STATE OF NEW JERSEY

Comments of the State of New Jersey on EPA's "Response to the September 2010 Section 126 Petition from New Jersey Regarding SO₂ Emissions from the Portland Generating Station," 76 Fed. Reg. 19,662 (April 7, 2011)

June 13, 2011

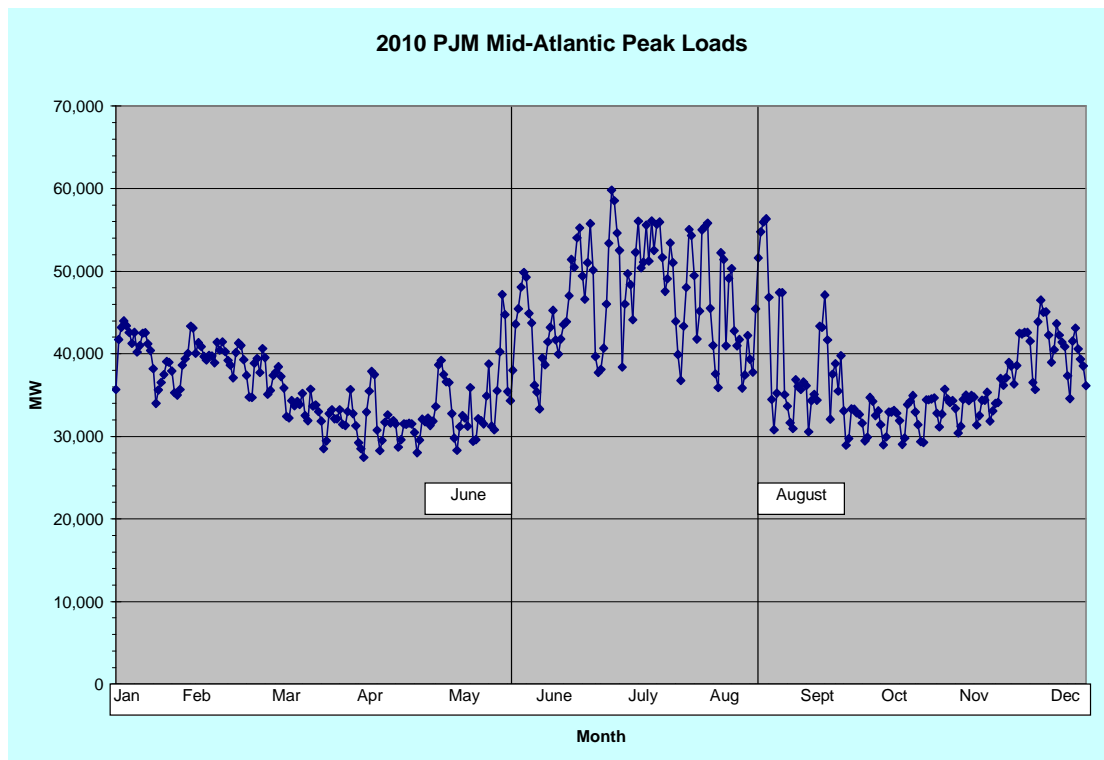
maximum timeframes, and GenOn should also be required to implement measures sooner if possible and demonstrate to EPA that they are doing so. The following information demonstrates that greater emission reductions than proposed by EPA are possible in shorter time frames and thus, the following are emission reduction measures that should be required to meet the "expeditiously as practicable" requirement set forth in Section 126. Section III of these comments explains in detail how such emission reductions can be achieved as "expeditiously as practicable."

For example, reducing the hourly amount of coal burned can be done immediately. GenOn should be required to do so and to demonstrate that it is minimizing the amount of coal burned within the capacity of the units. Also, GenOn should be required to burn the lowest sulfur coal available as soon as possible.

Also, GenOn can implement DSI in much less than one year and should be required to do so. Use of DSI would correspond to EPA's 50% reduction proposal within one year. GenOn should be required to document what is the soonest timeframe they can implement DSI and be required to do so in that timeframe, provided it is less than one year.

To allow operation beyond 90 days, GenOn should have reduced the amount of coal burned and the sulfur content of that coal, and installed DSI within the 90 day period. If an 80% reduction is not achieved within 90 days, GenOn should shut down the coal units until at least 80% reduction can be achieved. For example, if it takes longer than 90 days to obtain the lowest sulfur coal available, GenOn should not operate the coal units until that coal is on site and used.
